April 3, 2024

**RE: Lopez Quarry No. 2, Permit No. M-2007-034, Inspection Problem Corrective Action Submission**

**Figure 1:** Figure indicating agreed upon boundary marker locations.

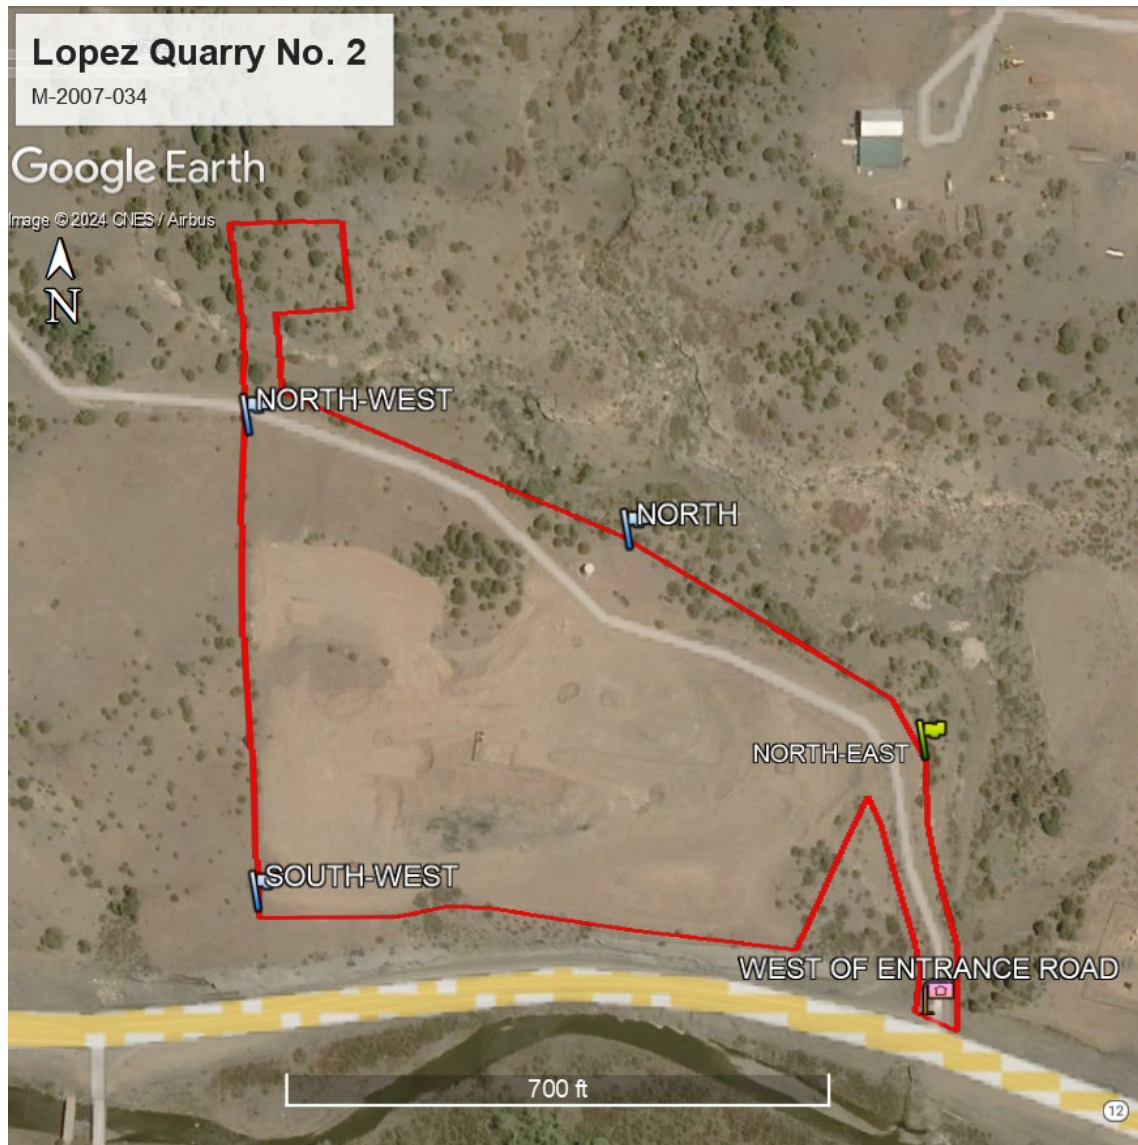
In response to the coordinate point for the north-east boundary marker that you submitted, the Division would like to address that the approved map is drawn at a scale that does not exactly match the landscape. The Division would like to clarify, for the record, that the permit boundary post's approximate coordinates around the affected area collected during the November 29, 2023 and March 26, 2024 inspections are in what will be furthermore considered as the recognized and accurate positions.

Below are the Division's estimates for the markers onsite (also, see Figure 1 below for reference). **The north-east corner of the affected area is the Division's estimate. The north-east corner post was not collected during the March 26, 2024 inspection.**

**Please provide a photo and coordinates of a marker in place in the south-east portion of the pit. If you concur with the Division's marker positions, please do so in an email response to this notice:**

- South-west: 37° 7'20.32"N, 104°46'31.55"W
- North-west: 37° 7'26.18"N, 104°46'31.59"W
- North: 37° 7'24.79"N, 104°46'25.78"W
- **North-east: 37° 7'22.00"N, 104°46'21.00"W**

- South-east: 37° 7'19.82"N, 104°46'23.33"W
- West side of entrance road to site: 37° 7'18.94"N, 104°46'21.05"W
